Wall Bracing Examples:

Building #1
One-Story

Steps used to determine wall bracing for Bldg. # 1

Steps used to determine wall bracing for Bldg. # 2

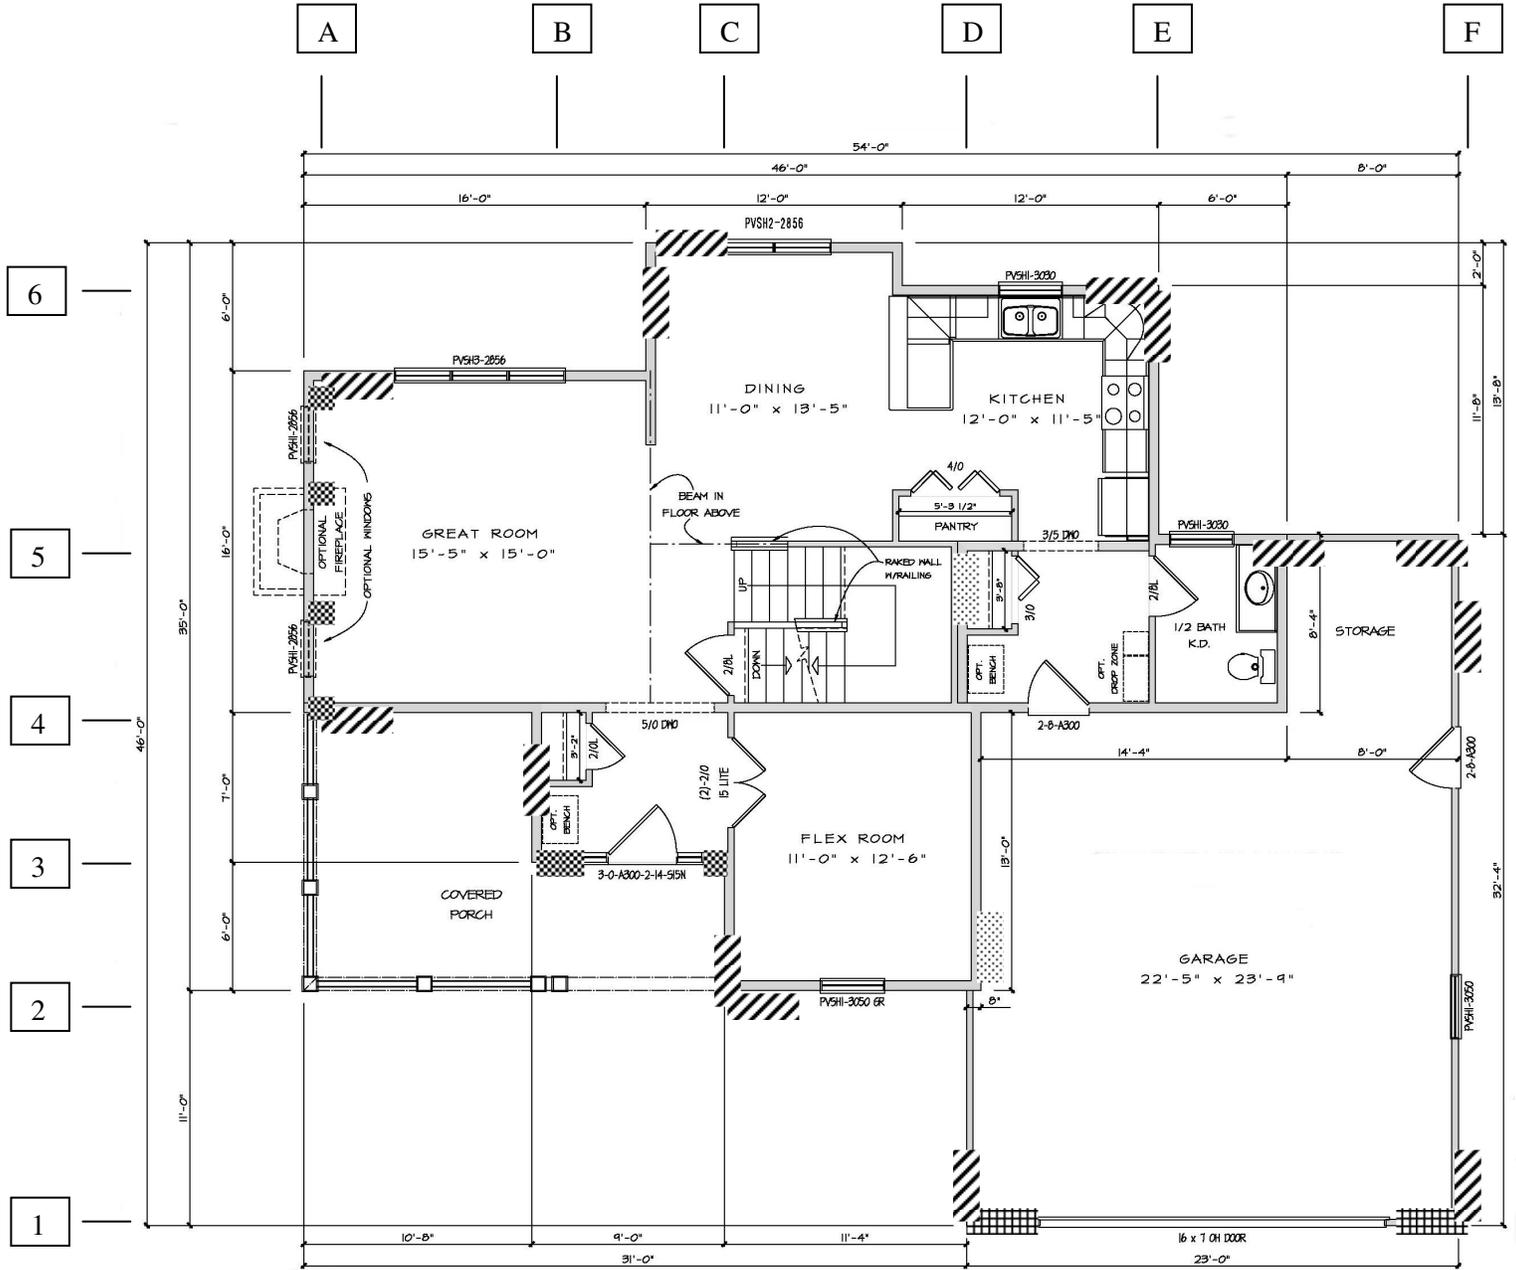
1. Find braced wall lines in exterior walls using analysis such as the plan north-south and east-west grid line pattern. Braced wall lines may include walls that are offset no more than 4 feet. [Comm 21.25(8)(e)]

2. Check the width of the building to determine whether or not an interior braced wall line is needed. (Spaced no more than 35 ft. apart, or up to 50 ft., with conditions.) [Comm 21.25(8)(e)1. & 2.]

- First check to see if you can comply with the wall bracing provisions of Comm 21.25(8) for 4 ft. wide panels or let-in bracing. This wall does not have the 4 ft. wide space available on either side of the garage door.

- An option, as identified on the plan, would be to use the continuously sheathed method of Comm 21.25(9)(c), Fig. 21.25-K with 2 ft. returns.
 - If the garage wall height is 9 ft., this design with the 3" nailing pattern and sheathing overlapping the header permits you to have sheathing on the sides of the garage door opening of 18" minimum. OK

- The percent of braced wall panels provided shall be checked for conformance with Comm 21.25(9)(c)5.c., Table 21.25-H. The length required for this wall line would be $23 \text{ ft.} \times 0.16 = 3.68 \text{ ft.}$ OK.

- Be reminded that the corners at the end of this braced wall line will have to be constructed in accordance with Fig 21.25-G.
- Another option to consider is Comm 21.25(8)(c)2.c., Table 21.25-G. If the wall height of the garage is 9 ft., braced wall panels could be reduced from 48" to 42" in width. If 42" width is provided, then the continuously sheathed method with 3" nailing pattern and 2 ft. returns would not be needed. This would still meet the percentage requirements of Tables 21.25-G and 21.25-H. [$23 \text{ ft.} \times 0.16 = 3.68 \text{ ft.}$ The effective length of 36 inches from Table 21.25-G $\times 2 \text{ sides} = 72" \text{ or } 6 \text{ ft.} > 3.68 \text{ ft.}$ OK]

4. Grid Line # 2 - Provide 4 ft. wide panels or let-in bracing within 12.5 feet of each end.

5. Grid Line # 3 - This grid line contains interior and exterior wall segments that are offset no more than 4 ft. from the braced wall line. Since this is considered one braced wall line, braced wall panels or let-in bracing must only be provided within 12.5 ft. of the ends and spaced no more than 25 ft. on center. As this is no more than 35 ft. from grid line #1 and grid line #4 this satisfies the maximum 35 ft. braced wall line spacing requirements. Note: Grid line # 4 was used for this spacing determination instead of grid line #5 as it is that exterior wall that has the majority of the braced wall panels to resist the wind loads.

6. Grid Line # 4 - Provide 4 ft. wide panels or let-in bracing within 12.5 ft. of each end and a maximum of 25 ft. on-center.

7. Grid Line # 5 - Provide 4 ft. wide panels or let-in bracing within 12.5 feet of each end. The plan shows two of 4 ft. wide panels. The code may be met by using just one panel in the center of the braced wall line as this would be within 12.5 ft. of each end. The single panel would also meet the percentage requirements of Table 21.25-H. [$15 \text{ ft.} \times 0.16 = 2.4 \text{ ft.} < 4 \text{ ft.}$ provided.]

- Provide 4 ft. wide panels within 12.5 ft. of each end and a maximum of 25 ft. on-center.
- Note: The plans show that let-in/diagonal bracing can be used in this braced wall line. After further review and consideration it has been determined that let-in bracing can not be used because this is a braced wall line that exceeds the 35 ft. braced wall line spacing requirement (grid lines A and D) resulting in a need for a check of an added amount of wall bracing required by Comm 21.25(8)(c)2. The use of grid lines B and C could not be considered in that spacing check above, as they do not extend to within 12.5 ft. of each endwall.
- Determine percent wall bracing required. Since the distance between braced walls lines A and D is 46 feet the required percentage would be $(46 \text{ ft.}/35 \text{ ft.} \times 0.16) \times 64 \text{ ft.}$ wall length = 13.5 ft. < 16 ft. provided. OK.

9. Grid Line B - Provide a 4 ft. wide panel within 12.5 ft. of each end.

10. Grid Line C - Provide 4 ft. wide panels within 12.5 ft. of each end. A single panel centered in the braced wall line would meet this requirement. Note, though, that a 2 ft. return may be required at the overhead garage door and the 4 ft. panel at the end would serve a dual purpose.

- This grid line contains interior and exterior wall segments that are offset no more that 4 ft. from the braced wall line. Since this is considered one braced wall line, braced wall panels or let-in bracing must only be provided within 12.5 ft. of the ends and spaced no more than 25 ft. on center.

- Note: The plans show that let-in/diagonal bracing can be used in this braced wall line. After further review and consideration it has been determined that let-in bracing can not be used because this is a braced wall line exceeding 35 ft. braced wall line spacing requirement (grid lines A and D) resulting in a check of an added amount of wall bracing required by Comm 21.25(8)(c)2.

- Determine percent wall bracing required. Since the distance between braced walls lines A and D is 46 feet the required percentage would be $(46 \text{ ft.}/35 \text{ ft.} \times 0.16) \times 47 \text{ ft.}$ wall length = 9.9 ft. < 16 ft. provided. OK.

12. Grid Line E - Provide 4 ft. wide panels or let-in bracing within 12.5 feet of each end and a maximum of 25 ft. on-center.

First Floor

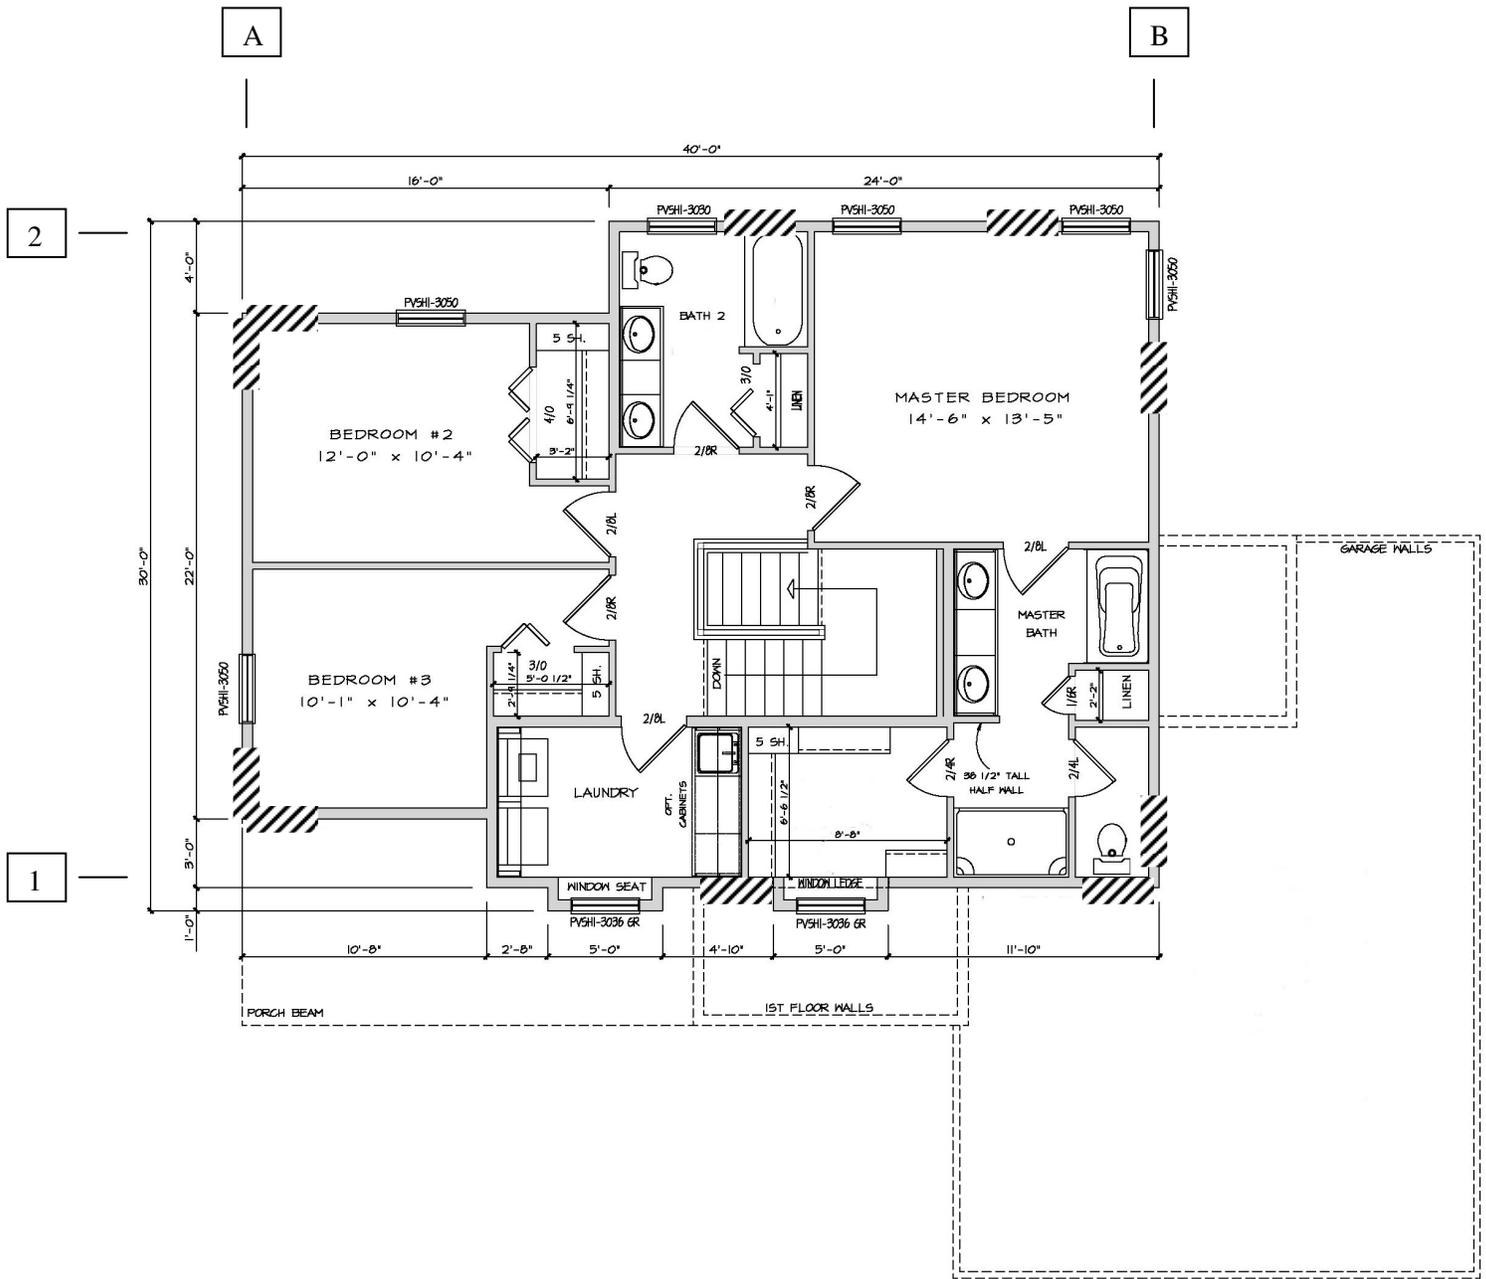
- First check to see if you can comply with the wall bracing provisions of Comm 21.25(8) for 4 ft. wide panels or let-in bracing. This wall does not have the 4 ft. wide space available on either side of the garage door.

- An option, as identified on the plan, would be to use the continuously sheathed method of Comm 21.29(9)(c), Fig. 21.25-K with 2 ft. returns.
 - If the garage wall height is 9 ft., this design with the 3" nailing pattern and sheathing overlapping the header permits you to have sheathing on the sides of the garage door opening of 18" minimum. OK

- The percent of braced wall panels provided shall be checked for conformance with Comm 21.25(9)(c)5.c., Table 21.25-H. The length required for this wall line would be 23 ft. X 0.16 = 3.68 ft. OK.

- Be reminded that the corners at the end of this braced wall line will have to be constructed in accordance with Fig 21.25-G.
- Another option to consider is Comm 21.25(8)(c)2.c., Table 21.25-G. If the wall height of the garage is 9 ft., braced wall panels could be reduced from 48" to 42" in width. If 42" width is provided, then the continuously sheathed method with 3" nailing pattern and 2 ft. returns would not be needed. This would still meet the percentage requirements of Tables 21.25-G and 21.25-H. [23 ft. X 0.16 = 3.68 ft. The effective length from Table 21.25-G of 36 in. X 2 sides = 72" or 6 ft. > 3.68 ft. OK]

4. Grid Line # 2 - Provide a 4 ft. wide panel or let-in bracing within 12.5 feet of each end.

- This wall does not have the 4 ft. wide space available on either side of the entrance door. The continuously sheathed method, as identified on the plan, will need to be used. In accordance with Table 21.25-J, the braced wall segments at the ends of this braced wall line will have to be at least 32 inches

wide and have return at the ends of at least 2 ft. [note not shown]. In addition the corners will have to be constructed in accordance with Fig. 21.25-G.

- An option, if the builder can not meet the 32" minimum braced wall panel length requirement, would be to use the continuously sheathed method of Comm 21.29(9)(c), Fig. 21.25-K with 2 ft. returns [not on shown on diagram]. The additional nailing and overlapping of sheathing over a header would permit a braced wall panel width of 16" in an 8 ft. high wall.

6. Grid Line # 4 - Provide a 4 ft. wide panel or let-in bracing within 12.5 ft. of each end.

7. Grid Line # 5 – Provide 4 ft. wide panels or let-in bracing within 12.5 ft. of each end and a maximum of 25 ft. on-center. The plan shows two of 4 ft. wide panels. The code may be met by using just one panel in the center of the braced wall line as this would be within 12.5 ft. of each end. The single panel would also meet the percentage requirements of Table 21.25-H. [$14 \text{ ft.} \times 0.16 = 2.24 \text{ ft.} < 4 \text{ ft.}$ provided.]

- This grid line contains exterior wall segments that are offset no more that 4 ft. from the braced wall line. Since this is considered one braced wall line, braced wall panels or let-in bracing must only be provided within 12.5 ft. of the ends and spaced no more than 25 ft. on center.
- Determine percent wall bracing required per Table 21.25-H.: $40 \text{ ft. wall length} \times 0.16 = 6.4 \text{ ft.} < 12 \text{ ft.}$ provided. OK.

- This wall does not have the 4 ft. wide space available between the fireplace and the windows, if all were provided in this braced wall line. The continuously sheathed method was identified as an option on the plan. In accordance with Table 21.25-J, this would mean that the braced wall segments at the ends of this braced wall line will have to be at least 24 in. wide if the wall is 8 ft. in height and the windows do not take up more than 67% of the wall height.

- If this width can not be met, the fireplace will have to go if the windows are provided and, if the fireplace is provided, the windows must go. Also, if the fireplace or windows are not provided there may be enough space in the braced wall line to get a 4 ft. braced wall panel in and thus eliminating the 2 ft. returns, and specially constructed corners per Fig. 21.25-G.

- Another option may be use Comm 21.25(9)(c)5., Fig. 21.25-K with 2 ft. returns.

10. Grid Line B - Provide a 4 ft. wide panel or let-in bracing within 12.5 ft. of each end.

11. Grid Line C - Provide 4 ft. wide panels within 12.5 ft. of each end. Note that as there is a 3'-8" difference in wall line of dining room and wall line of the flex room walls as designed, this can qualify as one wall line. With large openings in the center of this braced wall line, it would not likely to meet the 25 ft. spacing requirement, causing some additional analysis as shown in following for grid D.

- This grid line contains interior and exterior wall segments that are offset no more than 4 ft. from the braced wall line. As kitchen is only 11'-5" wide, this braced wall line meets the 12.5 ft. from kitchen exterior wall to interior braced wall gypsum sheathing between closet & stairs. Since this is considered one braced wall line, braced wall panels or let-in bracing must only be provided within 12.5 ft. of the ends and spaced no more than 25 ft. on center.
- Note: The plans show that let-in/diagonal bracing can be used in this braced wall line. After further review and consideration it has been determined that let-in bracing could be used because this is a braced wall line that does not exceed the 35 ft. braced wall line spacing requirement, since the distance between braced walls lines A and D is 31 feet. OK.

13. Grid Line E - Provide a 4 ft. wide panel or let-in bracing within 12.5 ft. of each end.

14. Grid Line F - Provide 4 ft. wide panels or let-in bracing within 12.5 feet of each end and a maximum of 25 ft. on-center.
